Response to RAI 1.1:

Response RAI 9.1:

Response to RAI-11.2.a

Figure 1 Nearest Residence Location

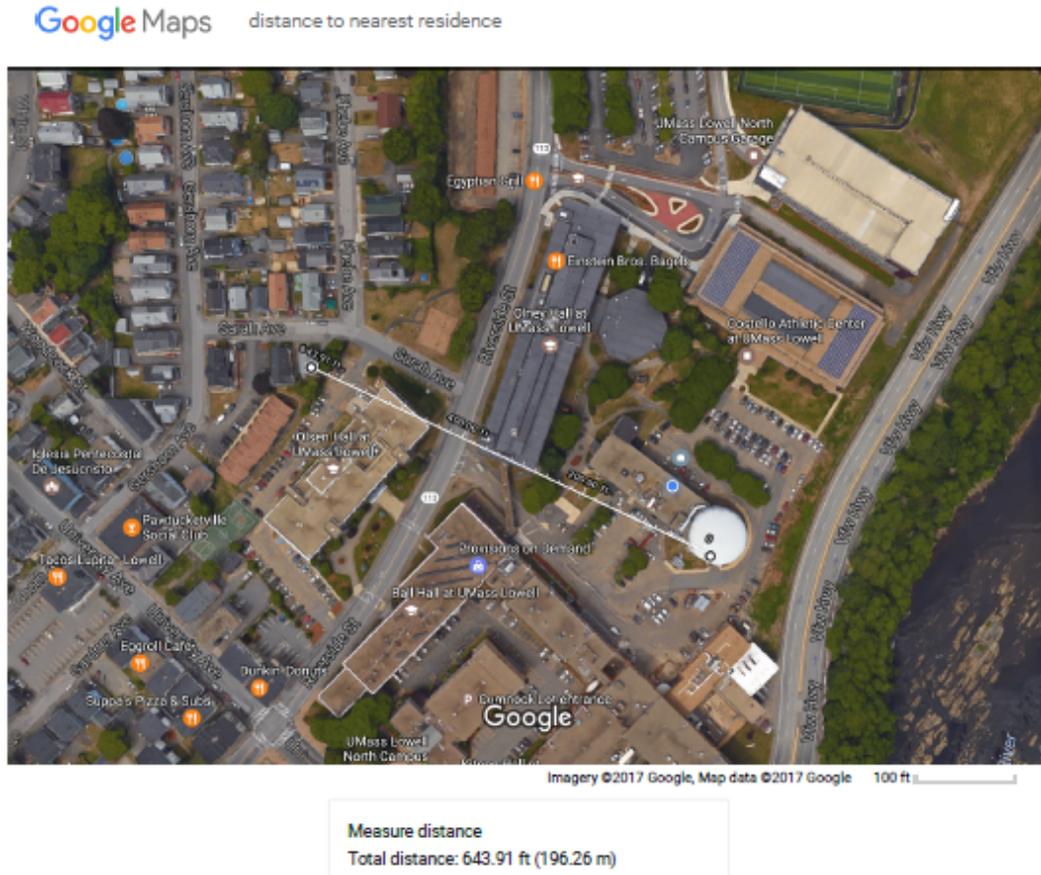
The nearest residence is approximately 200 meters away from the reactor facility stack in the west-north-west direction as shown on Figure 1. The dose to a member of the public, due to the assumed continuous full-power operation Ar-41 airborne release was calculated using the following formula (see also response to RAI-13.5.e):

Figure 2 Pasquille Stability Class Frequency Distribution

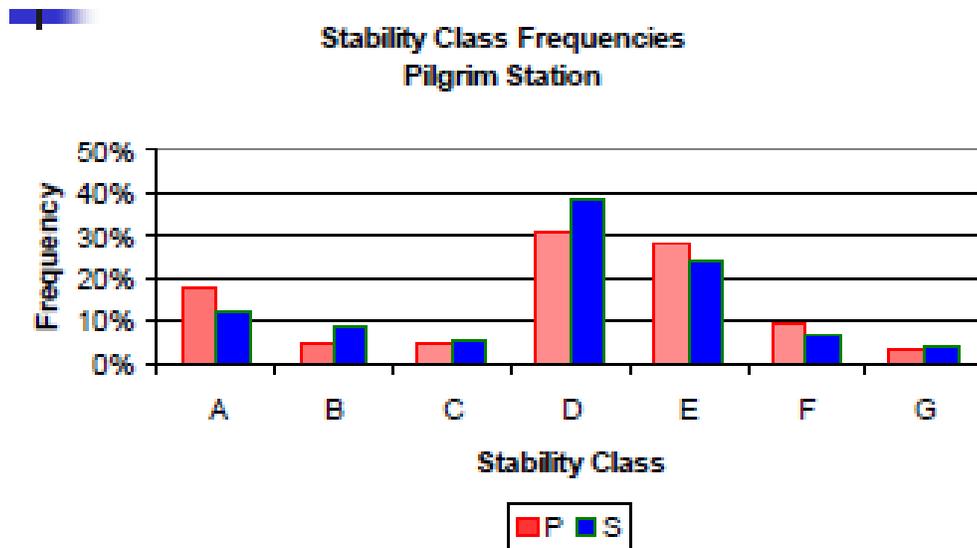
The available meteorological data, while including wind speed and direction, do not provide any indication of the stability classes for each specific measurement point. In order to illustrate the effect of historical stability class influence on the dose calculation, a typical stability class frequency distribution may be considered from the Pilgrim nuclear plant located in Plymouth Massachusetts. Figure 2 shows the stability class distribution frequency that was derived from measured temperature data using a weather tower with instruments at 10 and 60 meters height¹. An approximate effective dose value may be derived using the stability frequency distribution as a weight factor for each dose value as calculated by the above formula and ARCON96 for a specific stability class at a given distance. While site specific stability class frequency data is not available for the UMLRR, the stability class frequency averaged dose calculated using the Pilgrim distribution data illustrates the potential effect of varying stability class conditions.

Figure 3 Wind Direction Distribution for Hanscom Air Force Base January 1st 2013 – December 31st 2013

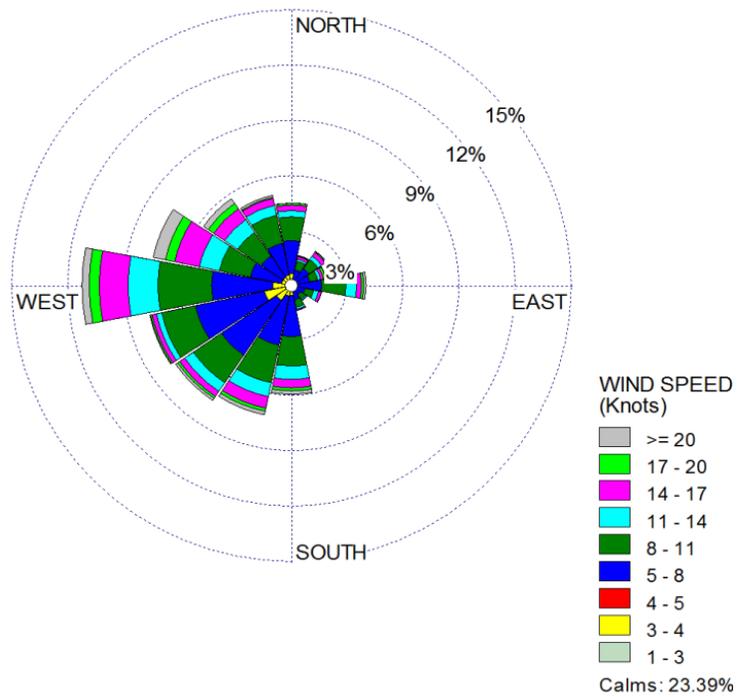
Figure 3 shows the final wind rose data being used in all calculations both for the Ar-41 and MHA fission product releases. The previous figures were incorrectly given using an earlier version of the meteorological data.

Figure 3 shows the final wind rose data being used in all calculations both for the Ar-41 and MHA fission product releases. The previous figure was incorrectly given using an earlier version of the meteorological data.

Fig. 1 Various views of the full storage rack model containing nine (9) fresh fuel elements.

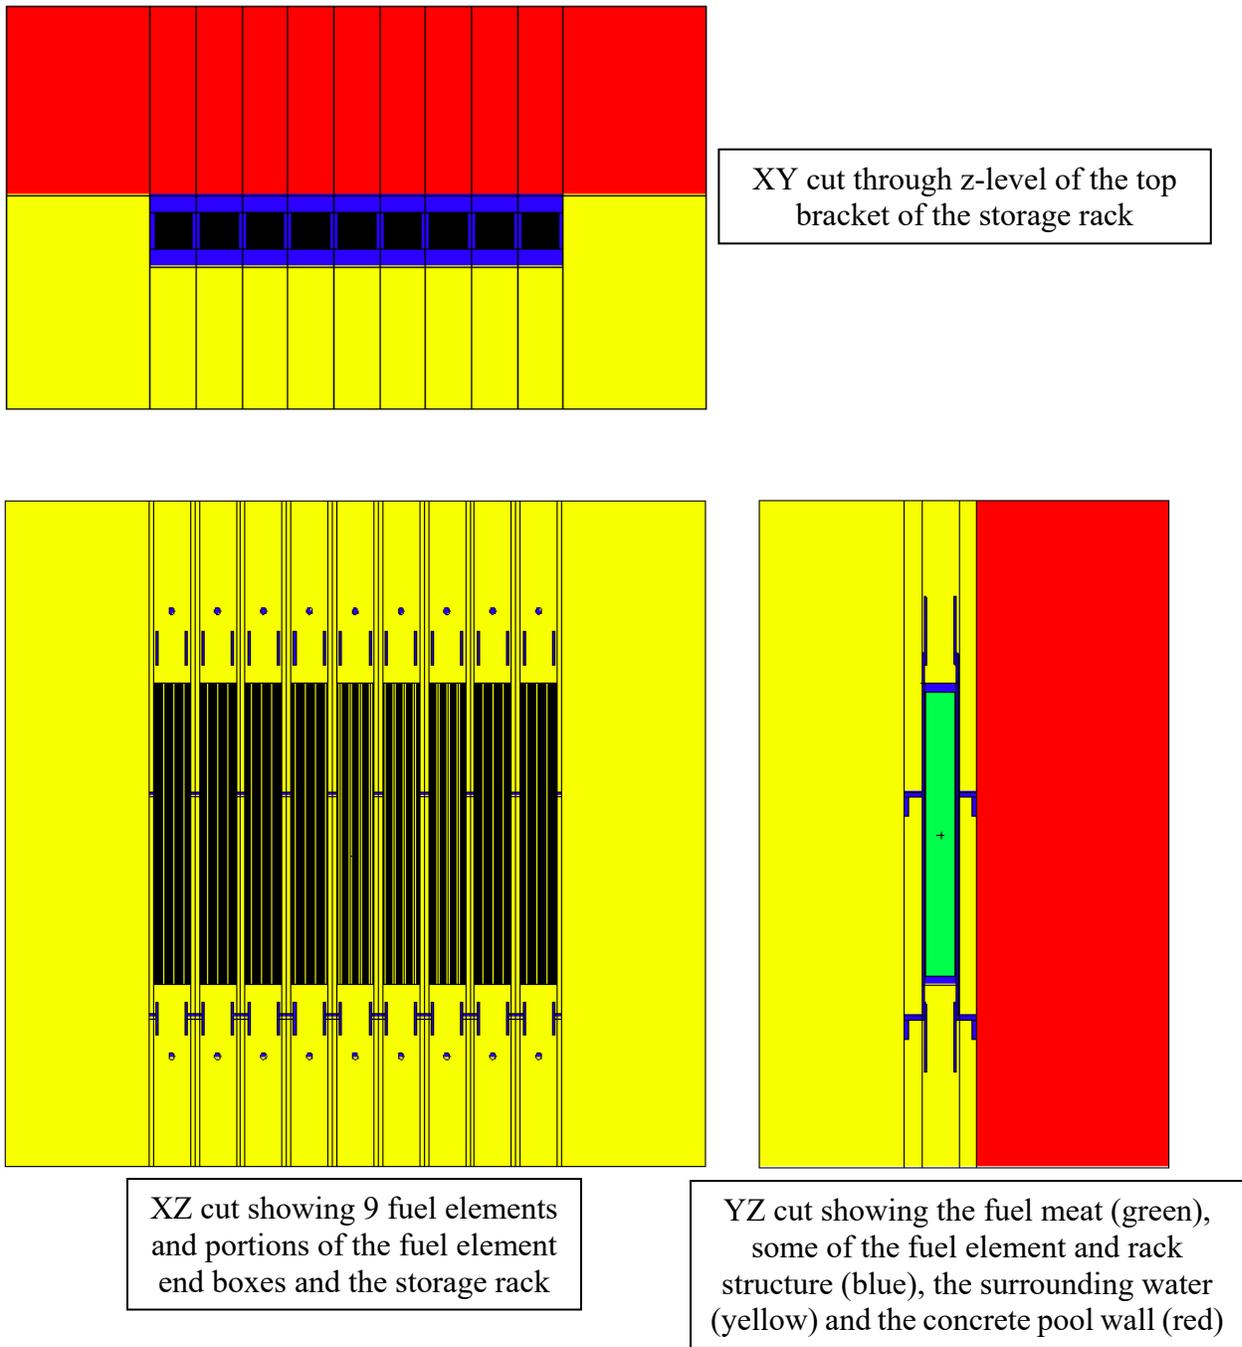
- b) The storage racks are designed and fabricated to hold a maximum of 9 elements. Figure 9-4 is a simplified depiction showing the main components of the fuel storage rack. A future update to the SAR will include a more accurate depiction for figure 9-4 to eliminate any confusion of the fuel rack storage capacity.

- a) The document entitled “UMLRR Storage Rack Criticality Analysis Results” dated August 11, 2016 is submitted as Appendix A of this response in support of the UML response dated August 11, 2016 (ADAMS Accession No. ML16224A322) to NRC Generic Letter 2016-01, “Monitoring of Neutron-Absorbing Materials in Spent Fuel Pools,” dated April 7, 2016 (ADAMS Accession No. ML16097A169). This document provides the additional detailed analyses as requested in RAI 9.1(a).
